LAKEWINDS SOUTH ELEVATION
1/8" = 1'-0"

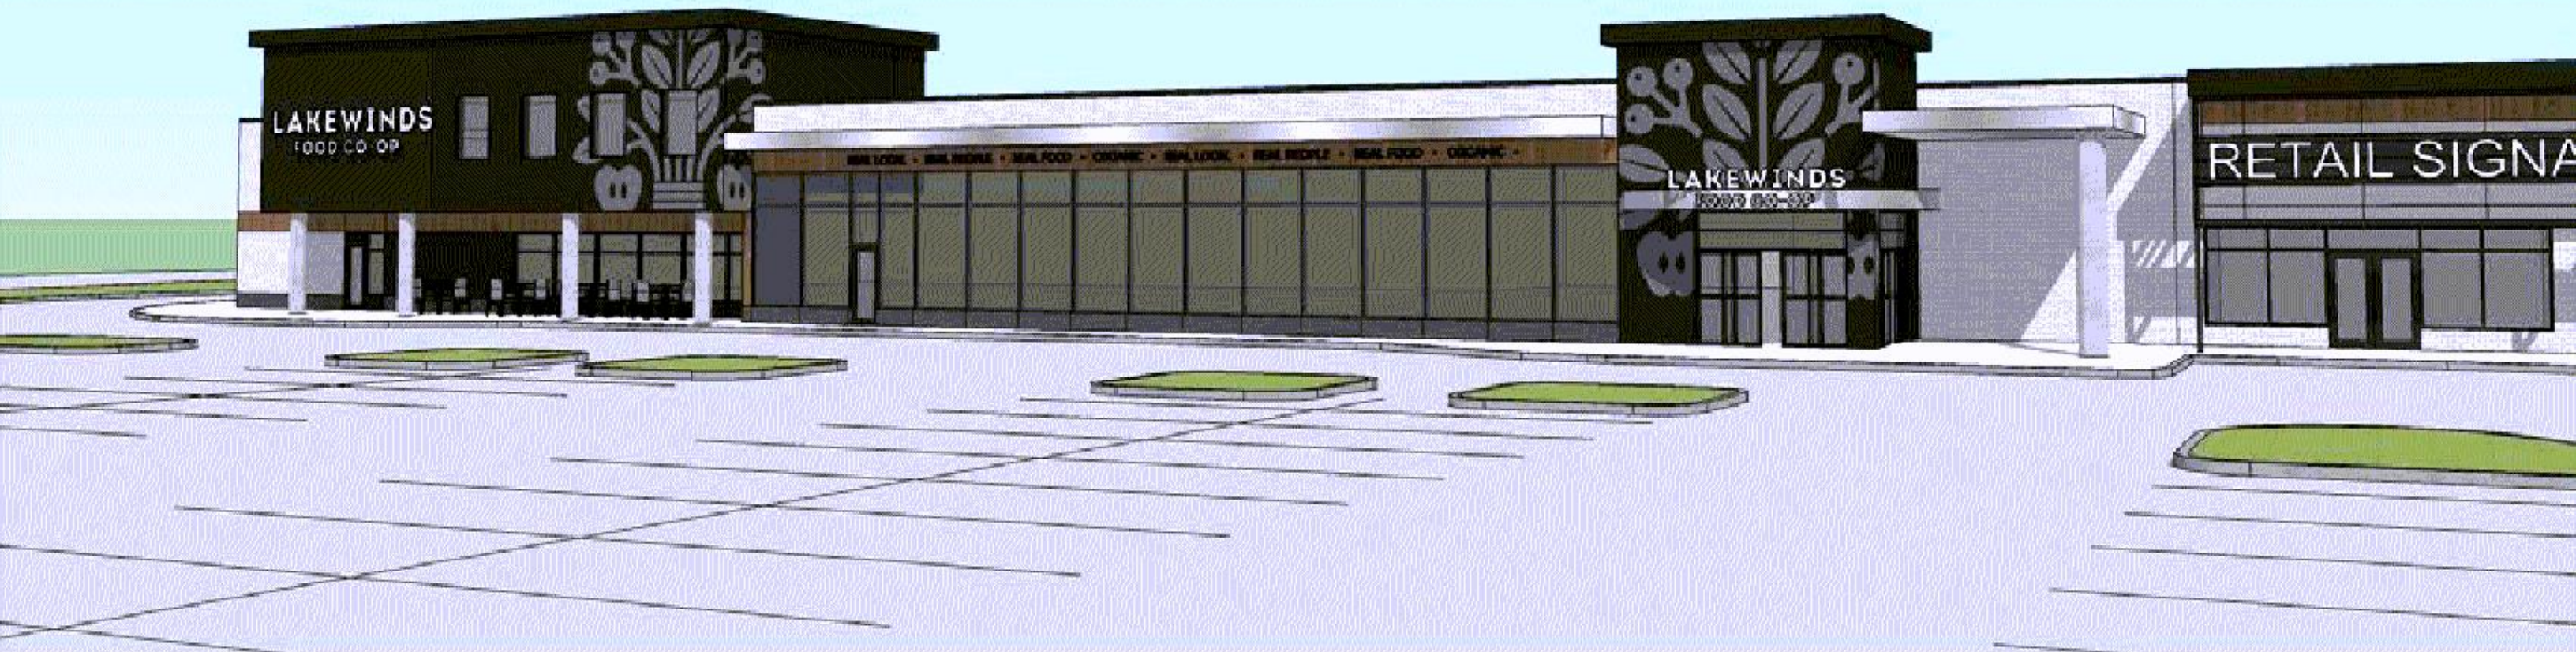
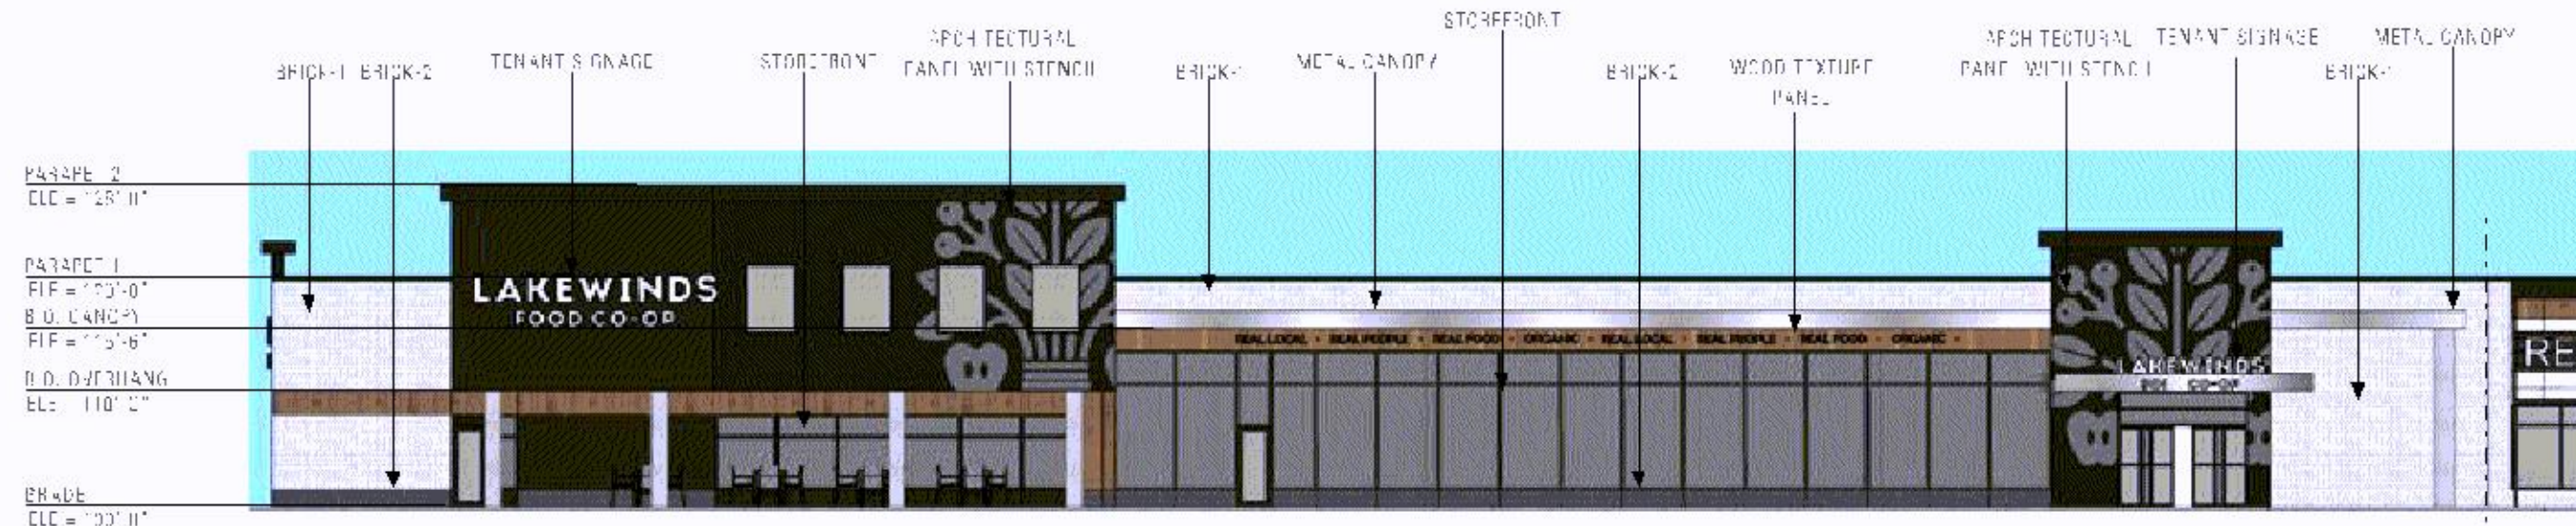
CMUs are not a permitted exterior building material. Select brick as the proposed building material or request a deviation to allow a split-faced CMU. Staff would need to evaluate the merits of that deviation from exterior materials standards.

LAKEWINDS WEST ELEVATION
1/8" = 1'-0"

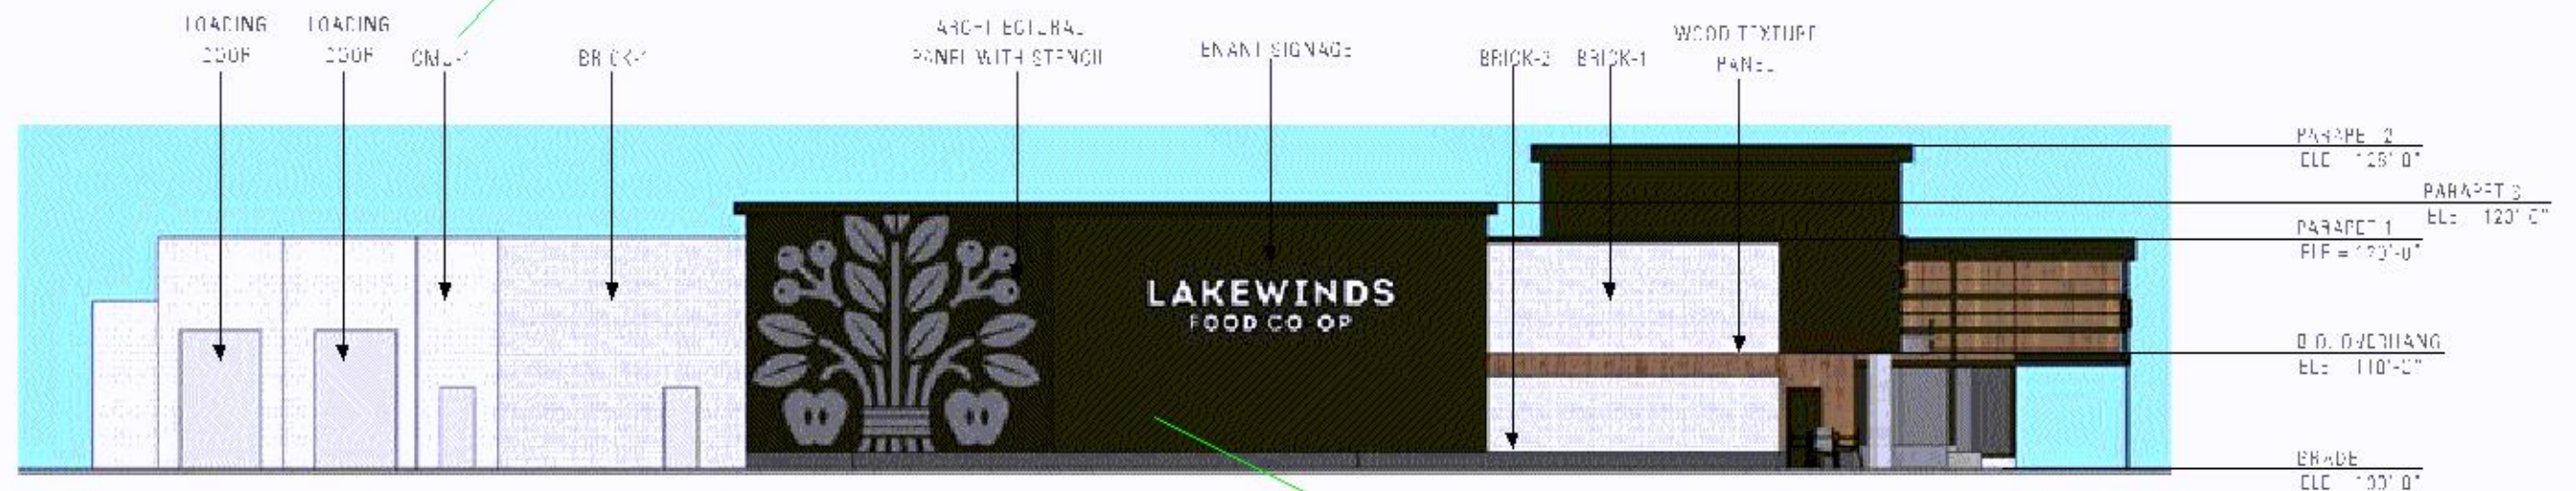
The north building elevation was not included in the submittal. What is proposed for the north elevation?

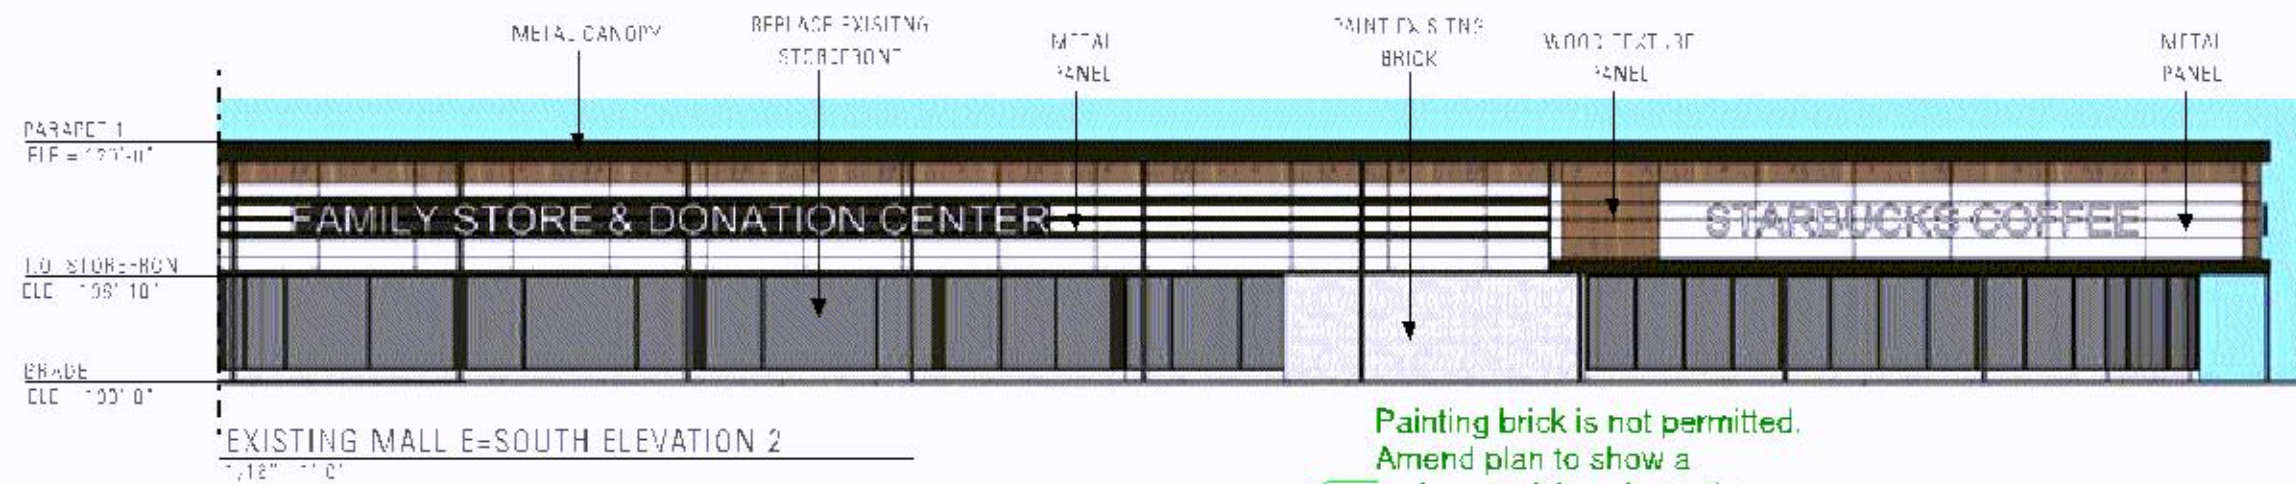
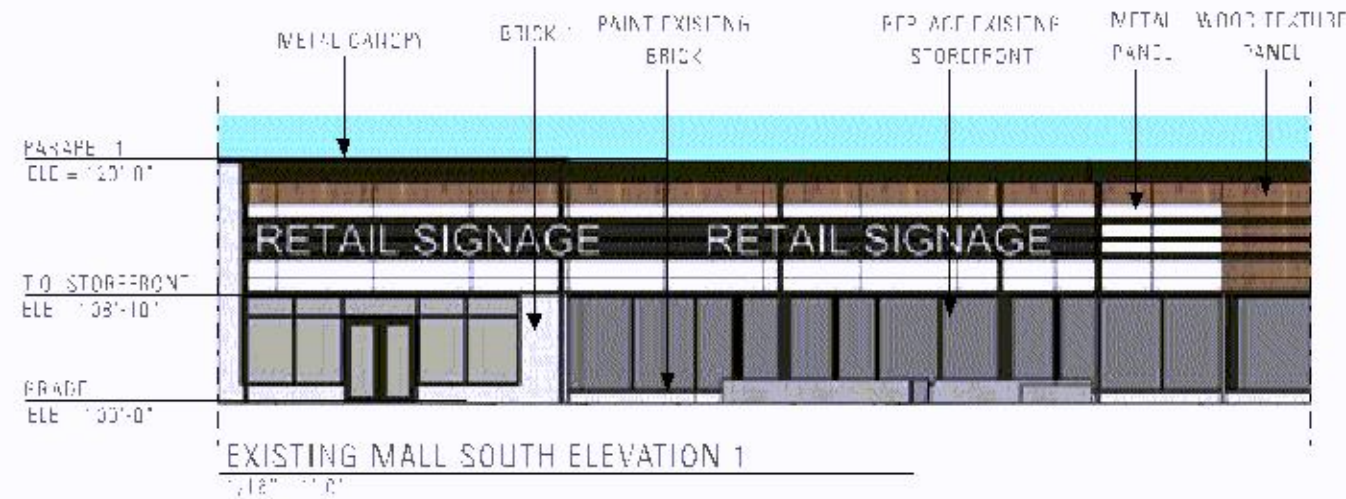
Are the "architectural panels" fiber cement panels? If so, they are limited to 15 percent of a given building elevation.

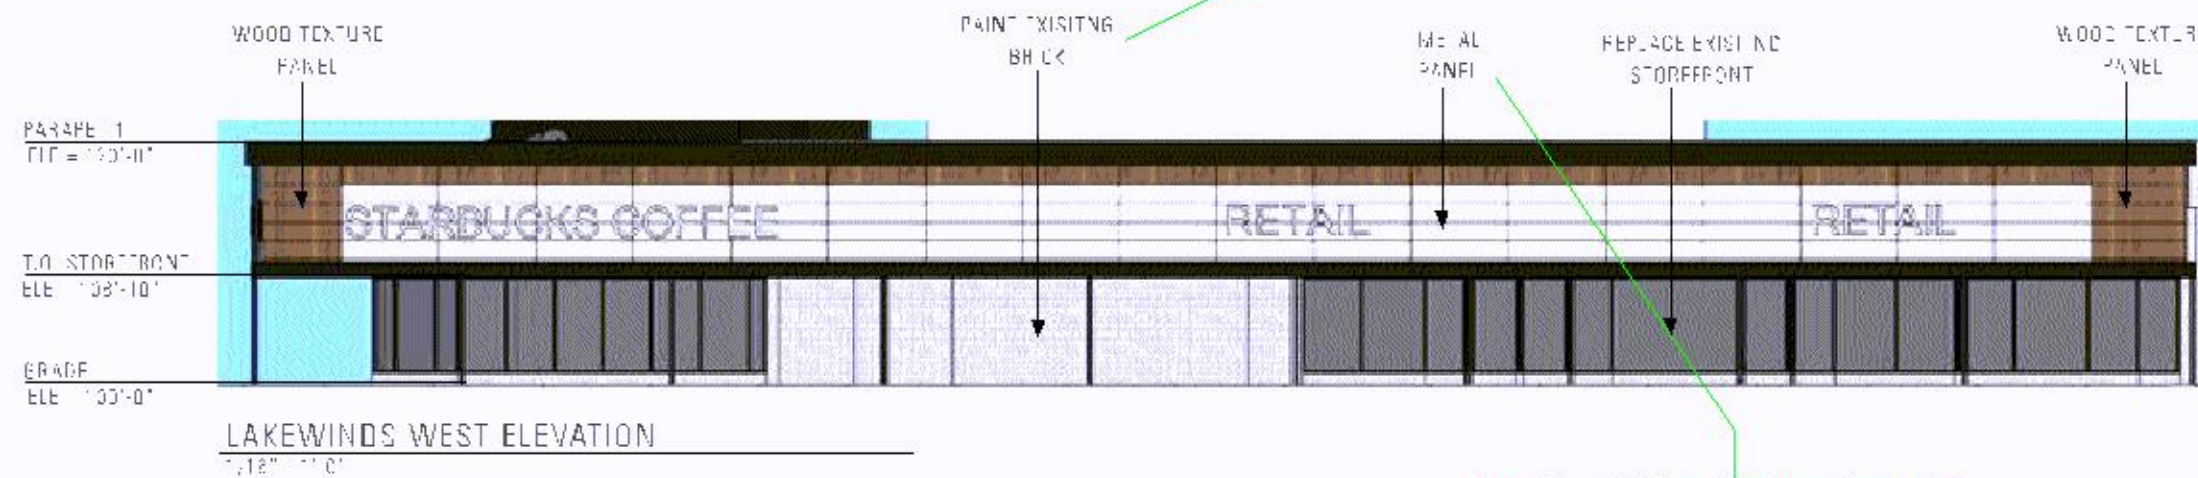
Painting brick is not permitted.
Amend plan to show a
code-complying alternative.

Provide additional information on the
proposed metal panels. There are
panel thickness and durability
requirements. Specifically, the City
requires a minimum 30-year
manufacturer finish warranty.
